Product Change Notification / LIAL-07RPOQ740

CCB 5135 Initial Notice: Qualification of a new lead frame with more Ag area on DAP surface prep for selected KSZ8081 and KSZ8091 device families available in 32L VQFN (5x5x0.9mm) package assembled at MTAI assembly site.

CCB#: 5135
Pre and Post Change Summary
PCN #: LIAL-07RPOQ740

Pre Change

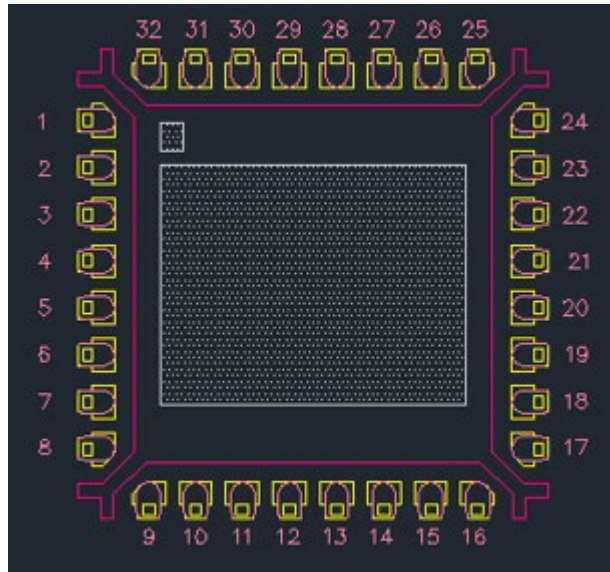
Lead frame DAP surface prep

Ag selective plating

Post Change

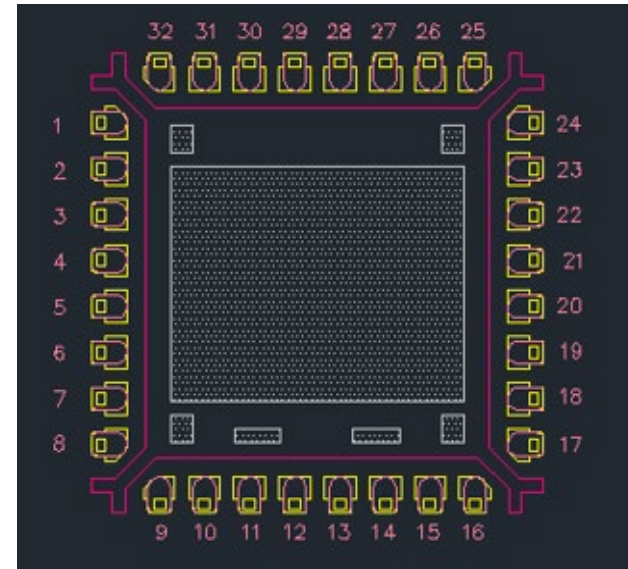
Lead frame DAP surface prep

Ag selective plating
(Add more Ag area)
